TECHNICAL BULLETIN
Bell Helicopter

No. 206L-09-234

MODEL AFFECTED: 206L-1 and 206L-3

SUBJECT: 5 VOLT LIGHTING SYSTEM, MODIFICATION OF

Figure 1. Lighting System Modification (Sheet 1 of 5)

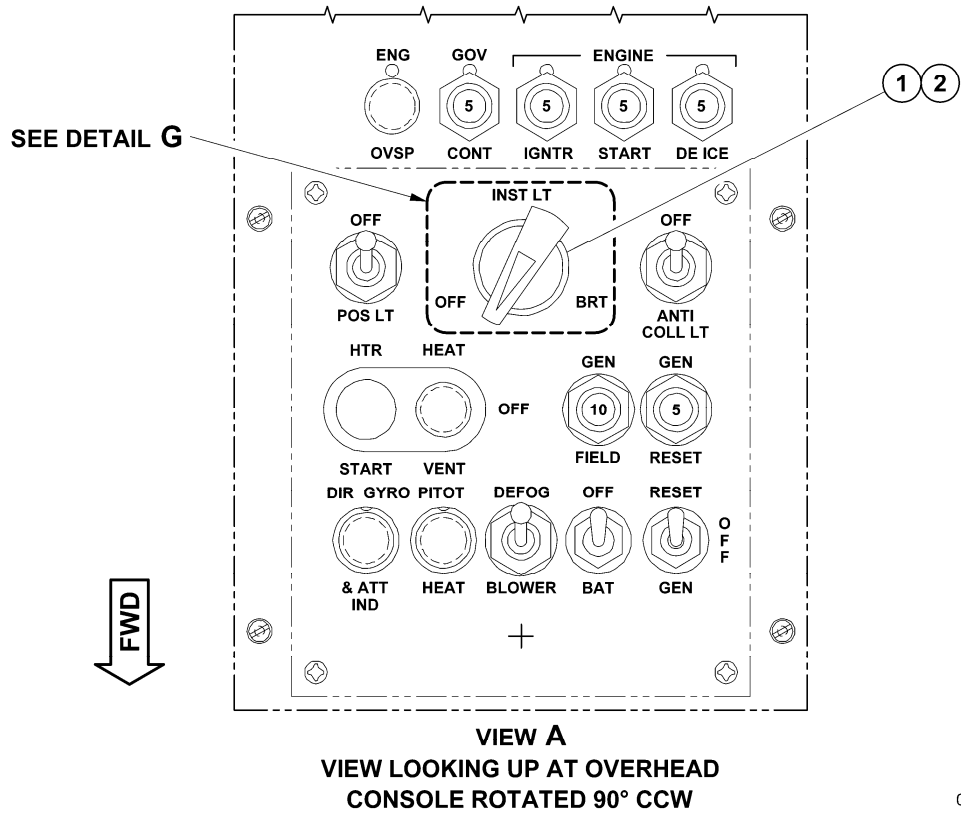
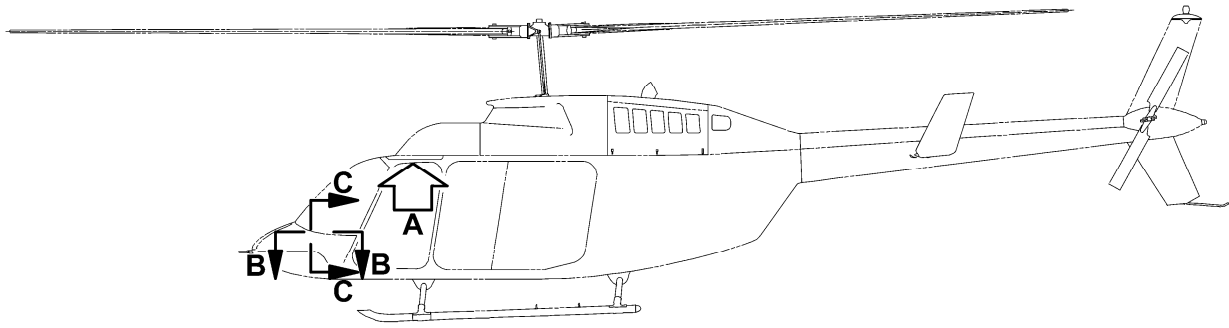
1. Prepare the helicopter for maintenance.
2. Ensure all electrical power is removed from the helicopter.
3. Disconnect the helicopter battery.
4. Remove console shroud assembly from top of instrument panel (Refer to BHT-206L1-MM-10, Chapter 95).
5. Remove windshield centre post fairing.
6. Remove R/H and L/H nose console covers to gain access to terminal board 8TB1 (5, Figure 1, Sheet 2).
7. Lower circuit breaker panel to gain access to potentiometer 8U1 (1, Sheet 1).

- **DELETE** - Remove the wire completely from the helicopter.
 - **RETERMINATE** – Reposition one end of the wire FROM its previous location TO a new location.
 - **ADD** - A new wire is required
8. Perform the "DELETE" actions listed in Table 2 for 206-704-735-101 and in Table 3 for 206-704-735-103.
 9. Remove and discard resistor 8R1 (4, Figure 1, Sheet 2) and bracket assembly with related hardware.
 10. Remove and discard transistor 8Q1 and diode 8CR1 (40 and 41, Sheet 3) with related hardware.
 11. Remove and discard potentiometer 8U1 (1, Sheet 1), resistors 8R3 and 8R4 (51 and 53, Sheet 4) and splice (55). Keep knob and installation hardware.
 12. Install potentiometer (2, Sheet 1) using previously removed hardware.

Figure 1. Lighting System Modification (Sheet 2)

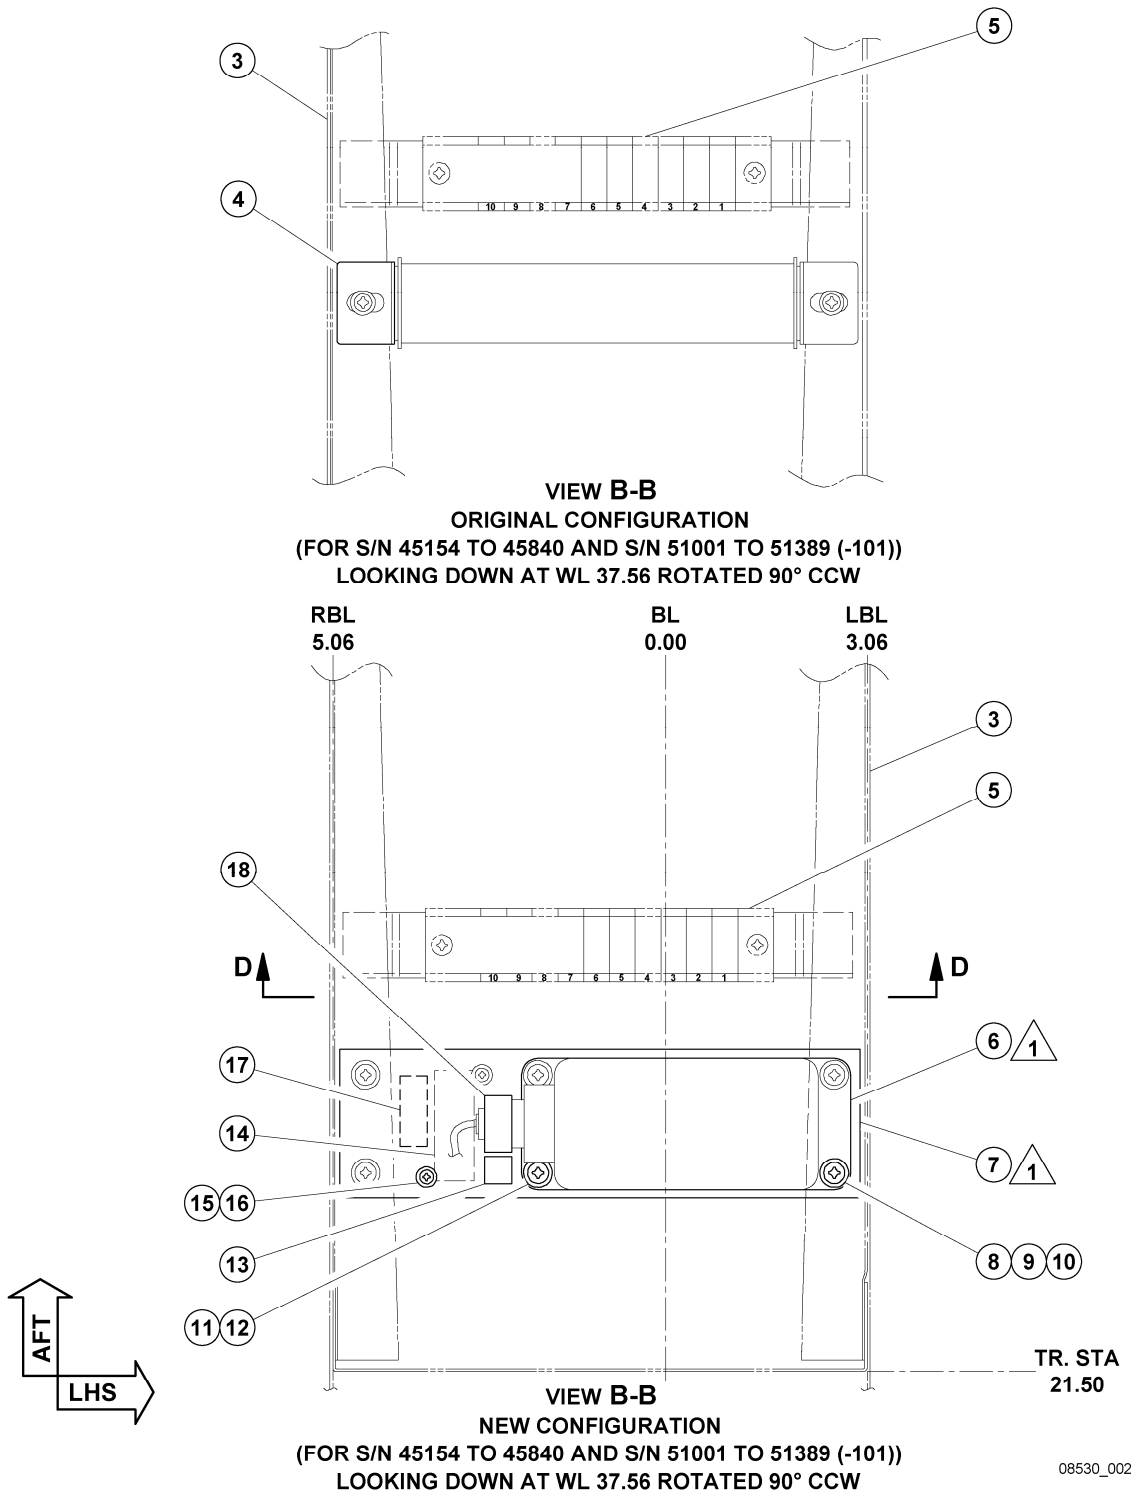
13. Install resistor 8R3 (52, Sheet 4).
14. Install resistor 8R4 (54).
15. Install diode 8CR2 (42, Sheet 3). Use flat washer (43), lock washer (44) and nut (45) as installation hardware.
16. Locate, drill and deburr holes .190 - .196 inch (4.83 – 4.98 mm) to frame (3, Sheet 4) by using existing 2 (two) holes and support (7, Sheet 2).

For ease of installation, wires L75A20 and L78B20 should be soldered on resistor 8R5 (14) prior to installing on support (7).

17. Install resistor 8R5 (14) on lower side of support (7) using screws (15) and nuts (16).
18. Locate support (7) on frame (3).
19. Install 5 volt power supply (6) on located support (7) using screws (8) and (11), washers (9) and (12), and nuts (10).
20. Perform the “RETERMINATE” actions listed in Table 2 for 206-704-735-101.
21. Perform the “ADD” actions listed in Table 3 for 206-704-735-101.
22. Continue on to Part II.

7. Remove R/H and L/H nose console covers to gain access to terminal board 8TB1 (5, Figure 1, Sheet 2).

Figure 1. Lighting System Modification (Sheet 3)

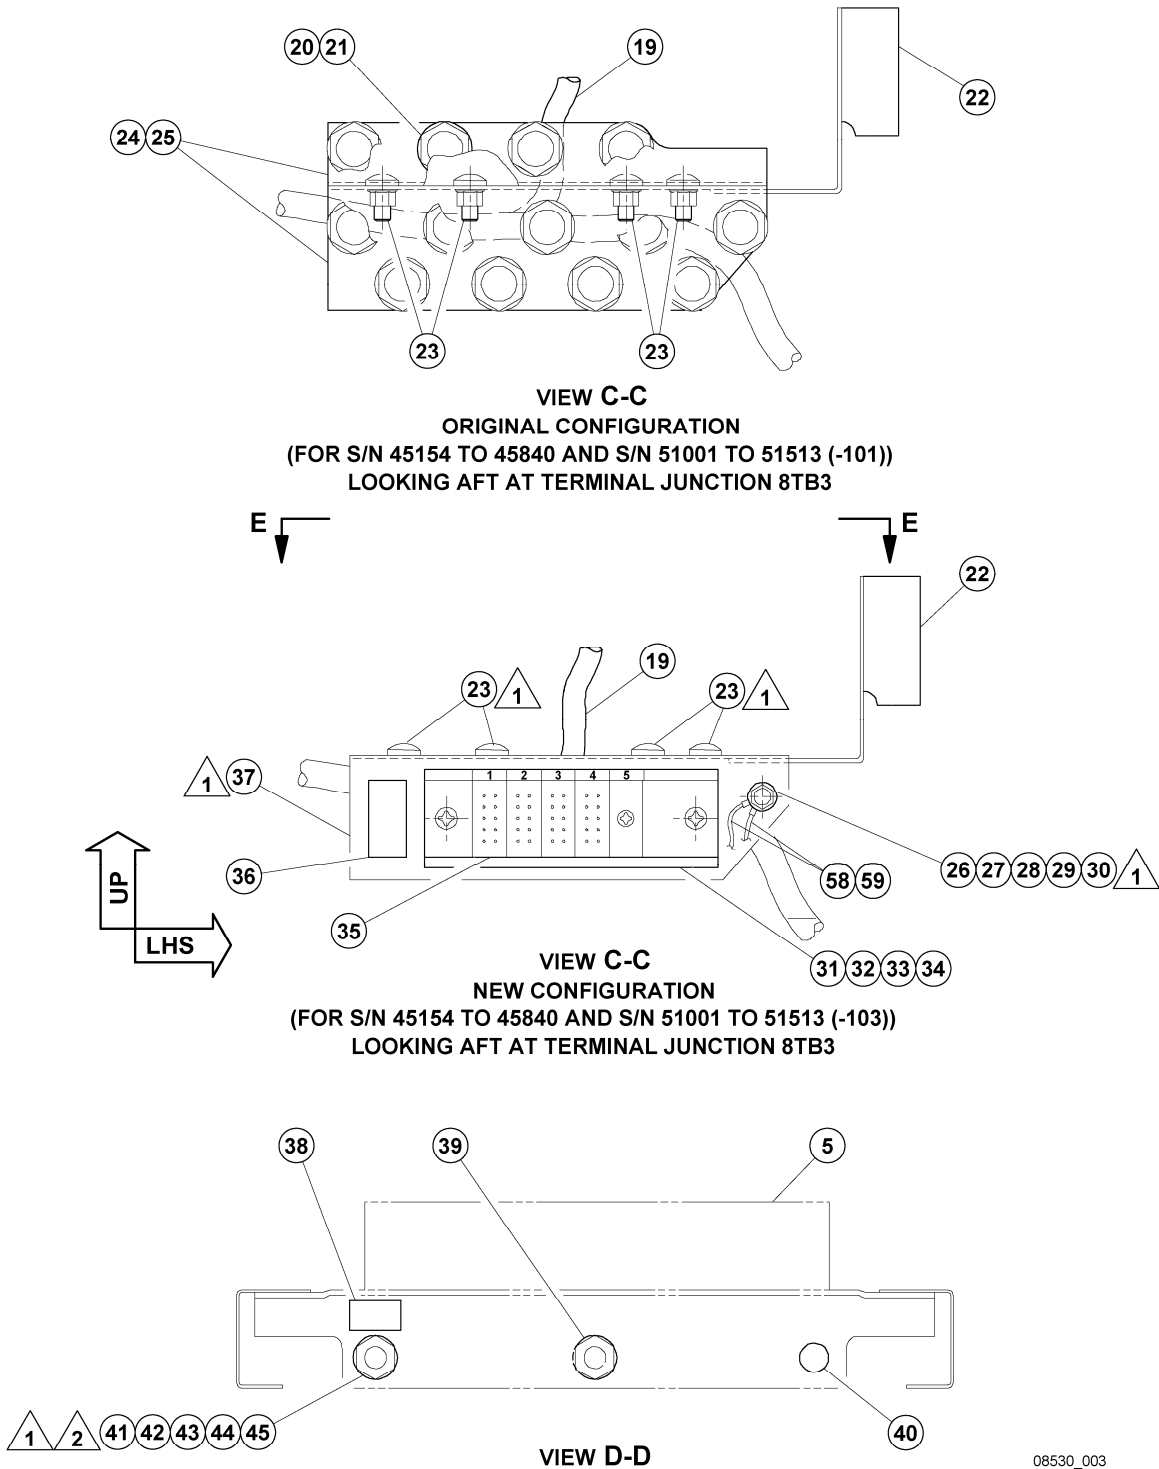
8. Perform the "DELETE" actions listed in Table 3 for 206-704-735-103.
9. Remove and discard chassis jacks 8J4 and plugs 8P4 (20 and 21, Sheet 3).
10. Disconnect ground studs (23) and clamps (46, Sheet 4) from support and angle (24 and 25, Sheet 3).
11. Remove wire bundle (19) from centre hole of support (24) by disconnecting upper connections and terminals.

12. Remove and discard both support and angle (24 and 25).
13. Locate, drill and deburr quantity eight (8) holes .1285 inch (#30 drill) on new support (37, Sheet 4) using existing holes from support (22) and from angle (50) (Refer to View E-E).
14. Bond grommet (49) using adhesive (C-301) on support (37).
15. Install support (37) using rivets (48).
16. Install terminal block rack 8TB3 (31, Sheet 3) using screws (32), washers (33) and nuts (34) on support (37).
17. Install terminal blocks (35) in terminal block rack (31).
18. Reinstall previously removed ground studs (23) and clamps (46, Sheet 4).

19. Reroute wire bundle (19, Sheet 3) through centre hole of new support (37) and reconnect upper connections and terminals.
20. Perform the "RETERMINATE" actions listed in Table 3 for 206-704-735-103.
21. Perform the "ADD" actions listed in Table 3 for 206-704-735-103.
22. Local ground for wires L175A20N and L176A20N (58 and 59, Figure 2, Wiring diagram) is located on support (37, Figure 1, Sheet 3) and is assembled with screw (26), washers (27) and (28) and nuts (29) and (30).
23. Perform the "ADD" actions listed in Table 4 for 8TB3 Lighting (Refer to BHT-ELEC-SPM chapter 4).
24. Perform the "RETERMINATE" actions listed in Table 4 for 8TB3 Lighting.

Wiring Diagram. 5 Volt Lighting System Post TB

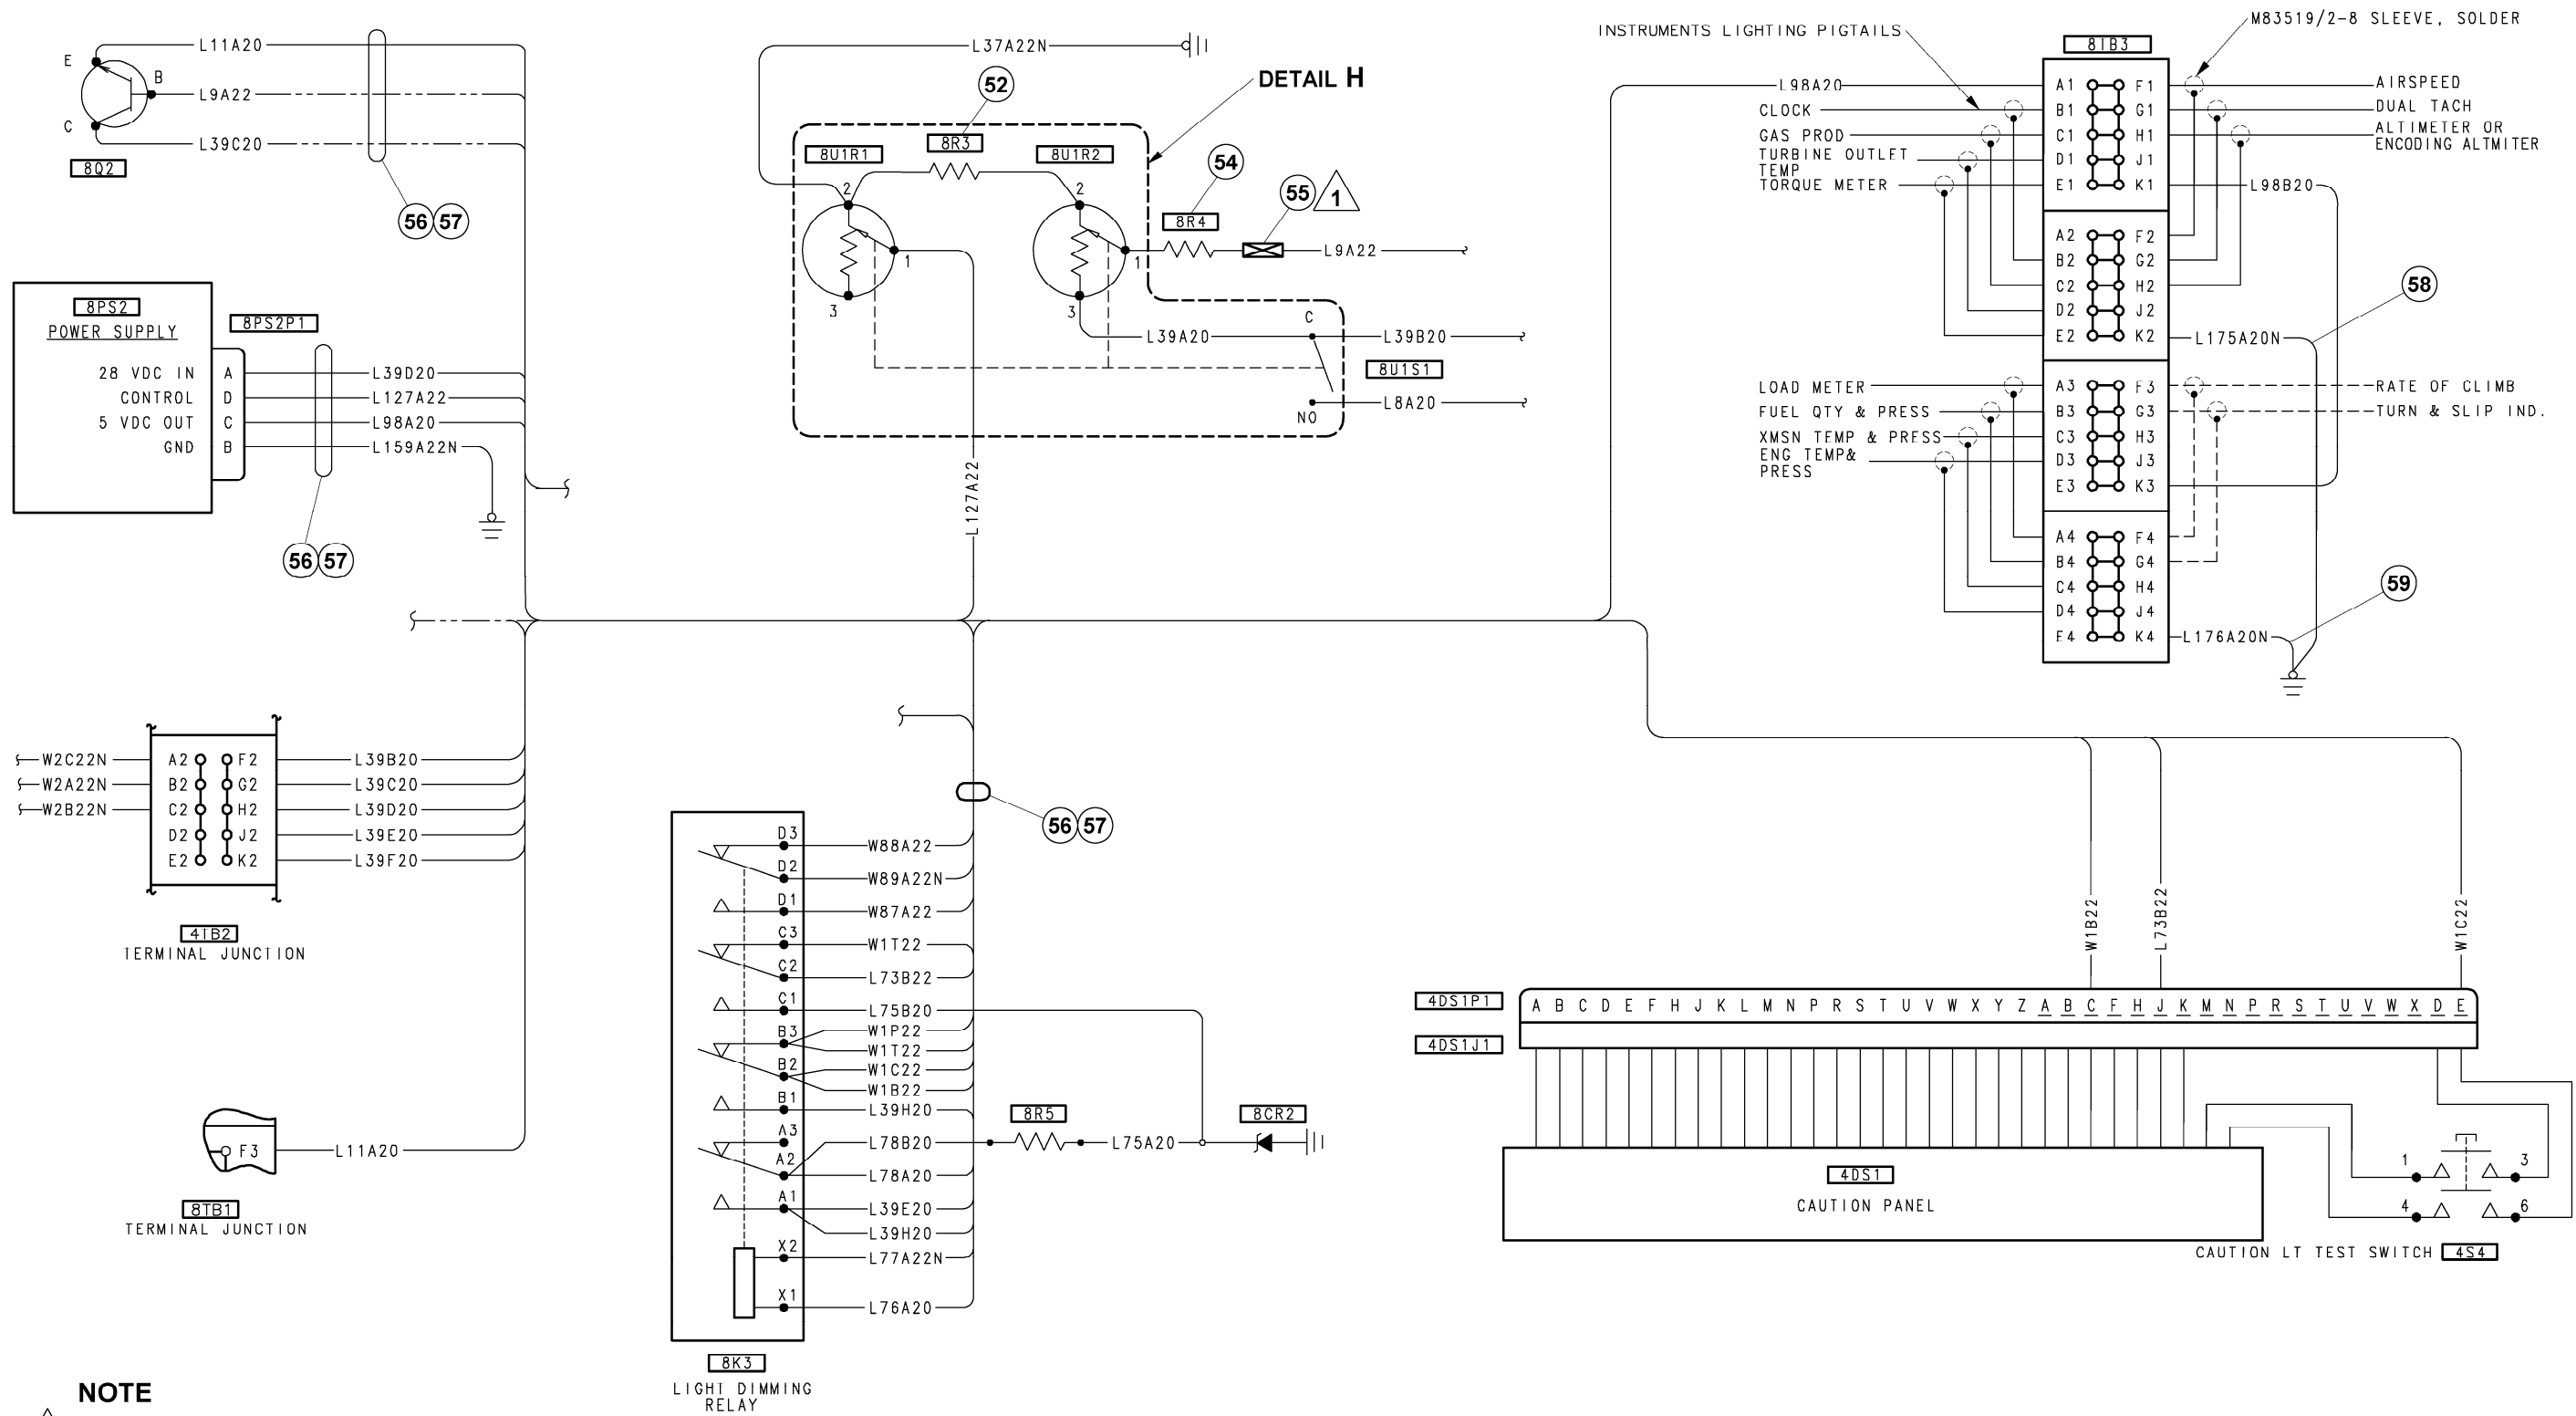
WIRING MODIFICATIONS INSTRUCTION TABLE FOR 8TB3 LIGHTING					
ACTION	WIRE	FROM	HARDWARE	TO	HARDWARE
ADD	SOLDER SLEEVE	CLOCK SHIELD	SLEEVE	8TB3-B2	M39029/1-101
ADD	SOLDER SLEEVE	GAS PRODUCER SHIELD	SLEEVE	8TB3-C2	M39029/1-101
ADD	SOLDER SLEEVE	TOT SHIELD	SLEEVE	8TB3-D2	M39029/1-101
ADD	SOLDER SLEEVE	TORQUE SHIELD	SLEEVE	8TB3-E2	M39029/1-101
ADD	SOLDER SLEEVE	LOAD/FUEL PRESS. SHIELD	SLEEVE	8TB3-A4	M39029/1-101
ADD	SOLDER SLEEVE	FUEL QUANTITY SHIELD	SLEEVE	8TB3-B4	M39029/1-101
ADD	SOLDER SLEEVE	XMSN TEMP. & PRESS. SHIELD	SLEEVE	8TB3-C4	M39029/1-101
ADD	SOLDER SLEEVE	ENG TEMP. & PRESS. SHIELD	SLEEVE	8TB3-D4	M39029/1-101
ADD	SOLDER SLEEVE	AIRSPEED SHIELD	SLEEVE	8TB3-F2	M39029/1-101
ADD	SOLDER SLEEVE	DUAL TACHOMETER SHIELD	SLEEVE	8TB3-G2	M39029/1-101
ADD	SOLDER SLEEVE	ALTIMETER SHIELD	SLEEVE	8TB3-H2	M39029/1-101
ADD	SOLDER SLEEVE	RATE OF CLIMB SHIELD	SLEEVE	8TB3-F4	M39029/1-101
ADD	SOLDER SLEEVE	TURN & SLIP SHIELD	SLEEVE	8TB3-G4	M39029/1-101

RETERMINATE	CLOCK	-	-	8TB3-B1	M39029/1-101
RETERMINATE	GAS PRODUCER	-	-	8TB3-C1	M39029/1-101
RETERMINATE	TOT	-	-	8TB3-D1	M39029/1-101
RETERMINATE	TORQUE	-	-	8TB3-E1	M39029/1-101
RETERMINATE	LOAD/FUEL PRESS.	-	-	8TB3-A3	M39029/1-101
RETERMINATE	FUEL QUANTITY	-	-	8TB3-B3	M39029/1-101
RETERMINATE	XMSN TEMP. & PRESS.	-	-	8TB3-C3	M39029/1-101
RETERMINATE	ENG TEMP. & PRESS.	-	-	8TB3-D3	M39029/1-101
RETERMINATE	AIRSPEED	-	-	8TB3-F1	M39029/1-101
RETERMINATE	DUAL TACH.	-	-	8TB3-G1	M39029/1-101
RETERMINATE	ALTIMETER	-	-	8TB3-H1	M39029/1-101
RETERMINATE	RATE OF CLIMB	-	-	8TB3-F3	M39029/1-101
RETERMINATE	TURN & SLIP	-	-	8TB3-G3	M39029/1-101
